DESIGN CHANGE AFFECTING TENSIONER LEVER 55925

TECHNICAL INFO NO. 1020

Figure 1: 55925 - current design

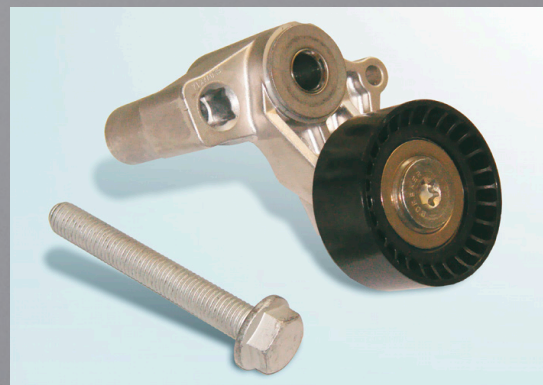
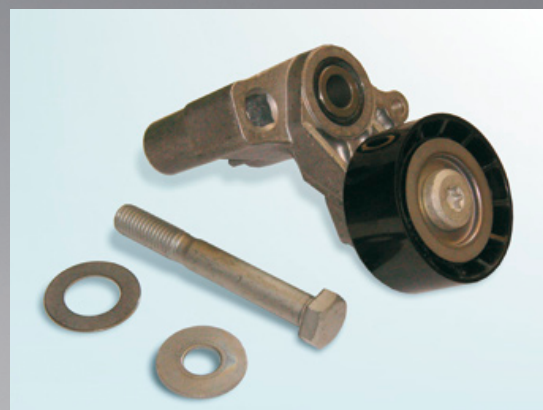
As part of our continuous efforts to improve our products, changes have been made to the design of tensioner lever 55925.

The accessory parts which were previously loose (washers) are now fixed to the tensioner lever.

The fixing bolt has also been modified.

Only the new screw supplied can be used with the new design. Other screws or older screws are not permitted!
Use the torque prescribed by the vehicle manufacturer to tighten the fixing bolt.
Follow the vehicle manufacturer's instructions!

During the transitional phase, we may have mixed stocks of both types. Both versions fulfil the relevant technical specification and can be used without restrictions.
